## INDEX TECHNICAL SERVICE BULLETIN

**TDxFLx® (67)**

SUBJECT:  
**TDxFLx® Analyzer Revision 3.0 Software Upgrade**

TSB#: **67-013**

Figure 1

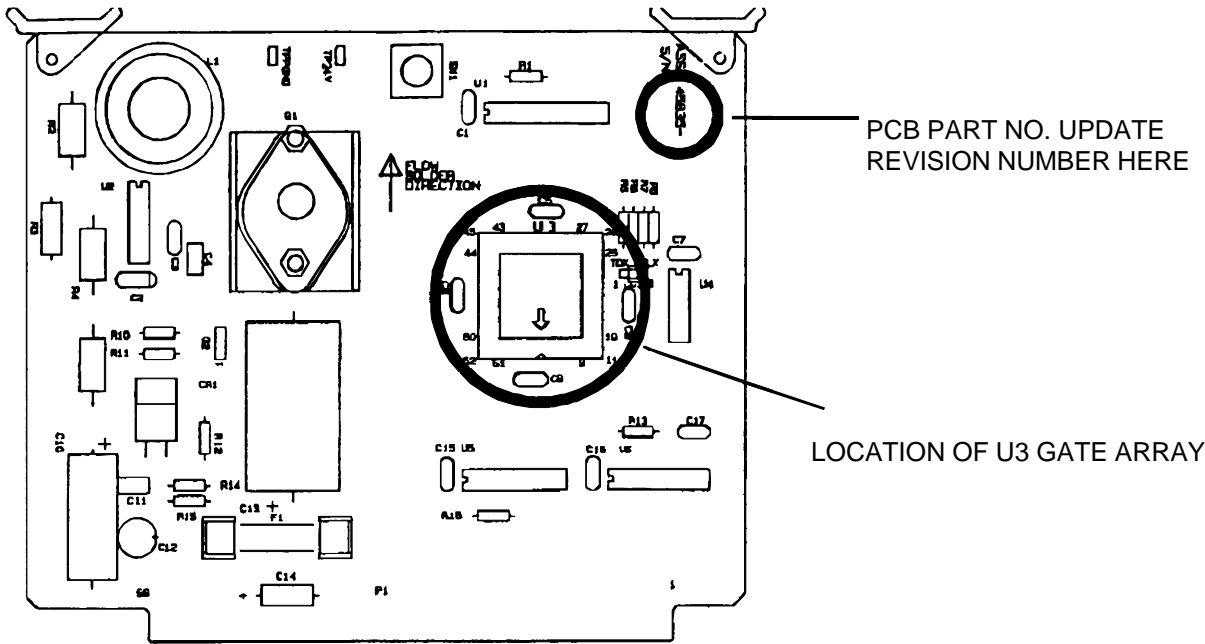
- STEP 4. Observing proper static precautions, place Bd. 9 on a static mat and locate U3. (See Figures 1 and 2 for location.)
- STEP 5. Before removing the gate array from the socket, find the orientation dot on the gate array. See Figure 2.

Figure 3

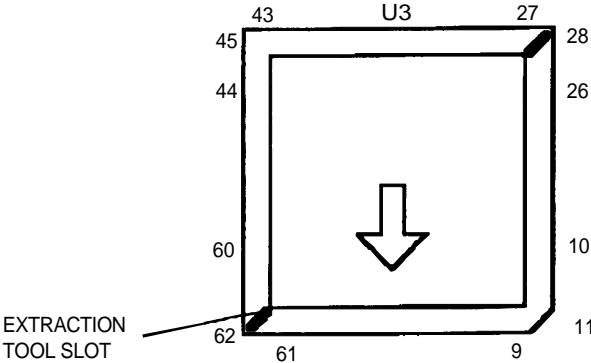
- STEP 6. Insert the extraction tool fingers into the slots of the I.C. socket. The slots are diagonally across from one another. See Figure 3 for slot position.

45290-102  
NON-VDE  
MOTHERBOARD

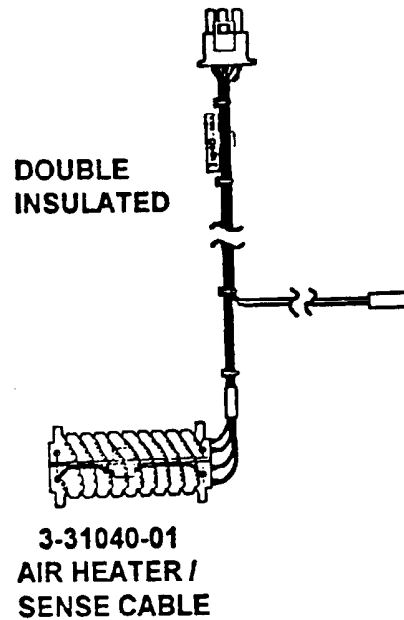
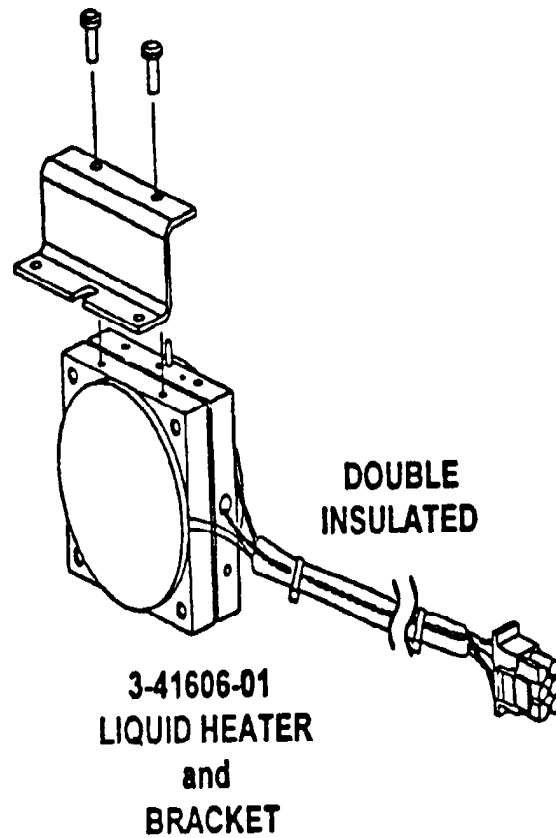
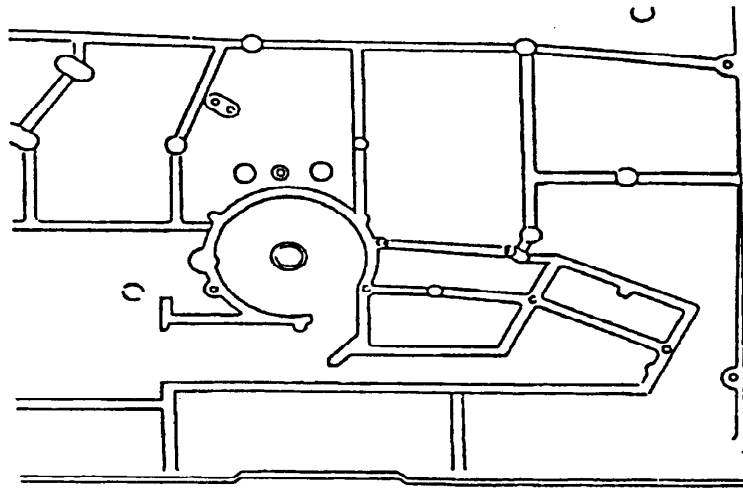
3-45003-02	CARD CAGE ASSEMBLY	3-45003-01	Y
3-31009-01	PMT HIGH VOLTAGE SUPPLY	3-31009-01	Y
3-31040-01	AIR HEATER/SENSE CABLE ASSY	3-31040-01	NO
3-41606-01	LIQUID HEATER/BRACKET ASSY	3-41606-01	NO
45240-101	MOTHERBOARD PCB (only)	45290-102	Y
45171-104	BASEPLATE, MODIFIED	45171-103	NO
45257-102	BARCODE WAND HARNESS ASSY	45257-101	NO
45303-101	COVER, LIQUID HEATER	NEW PART	NO
45319-101	SPILL GUARD	NEW PART	NO
45320-101	SPILL GUARD SEAL	NEW PART	NO
45327-101	GROUND STRAP #3	NEW PART	NO
45330-101	ADAPTER CABLE, 31002 to 45302	NEW PART	NO
14108-020	FERRITE BEAD, TOROIDAL	NEW PART	NO
14108-047	FERRITE, ROUND CABLE	NEW PART	NO
14108-046	FERRITE, FLAT CABLE	NEW PART	NO

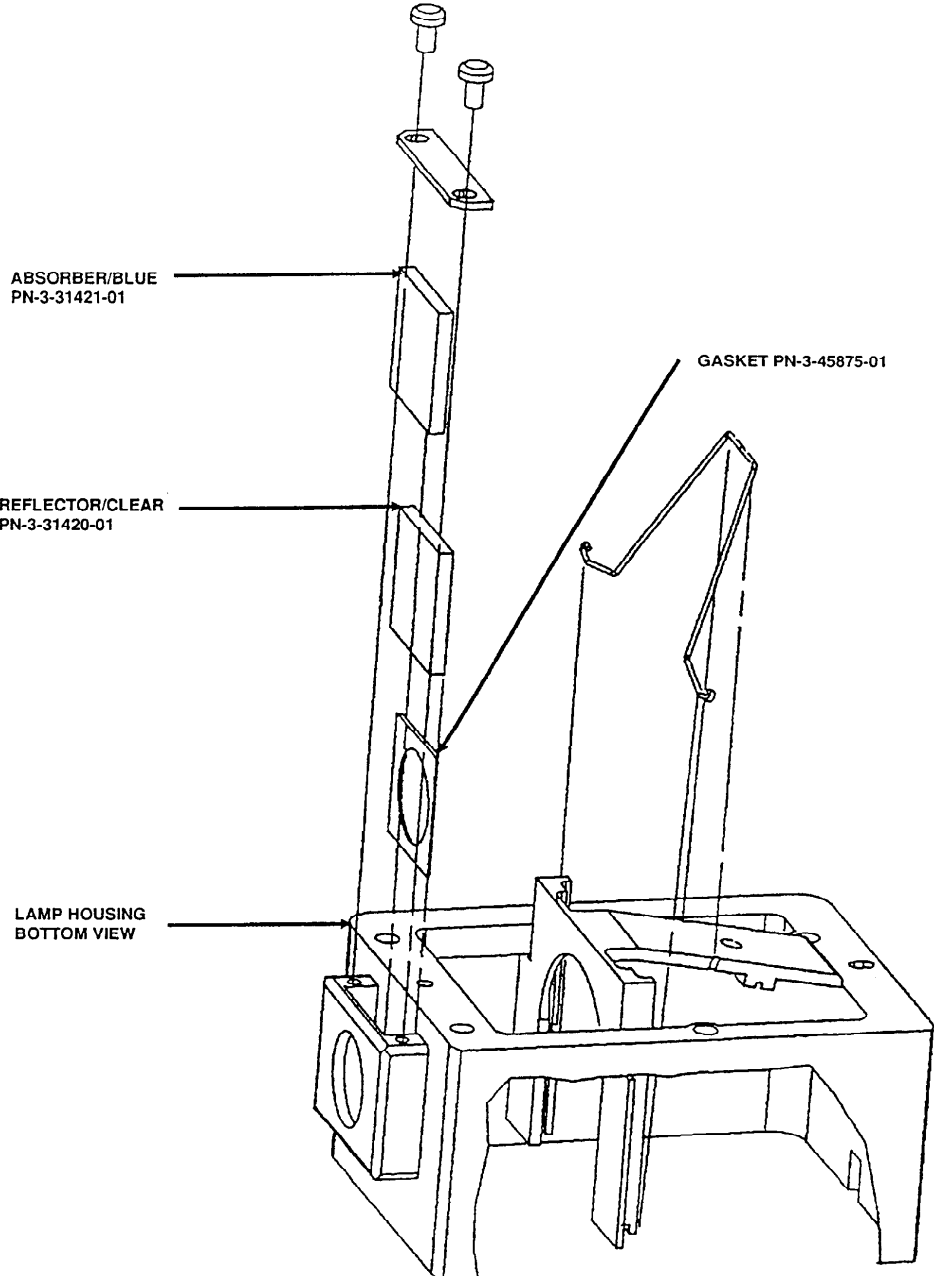
6. Clean the heat glasses with lens paper and replace them in the housing (See ISA 09-078 for proper placement). Insert one or two gaskets (PN 3-45875-01), as necessary, to create an airtight fit between the body of the lamp housing and the heat reflector (See Drawing).

Figure 2A

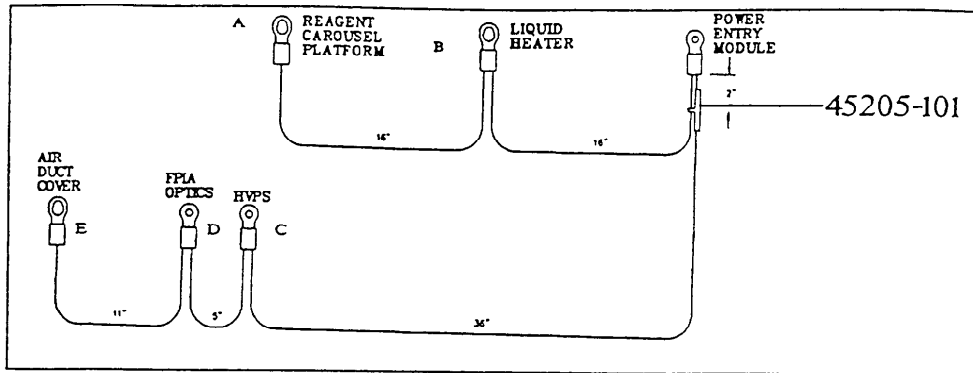
10. Install grounding cable #1 and #2. See Figures 2A, 2B and Top Assembly drawings for the location and attachment of each cable. The ends are attached to the grounding lug inside the power entry module.
11. **\*NOTE 1: The point of attachment on the back panel must be scraped to remove the paint for better contact.**
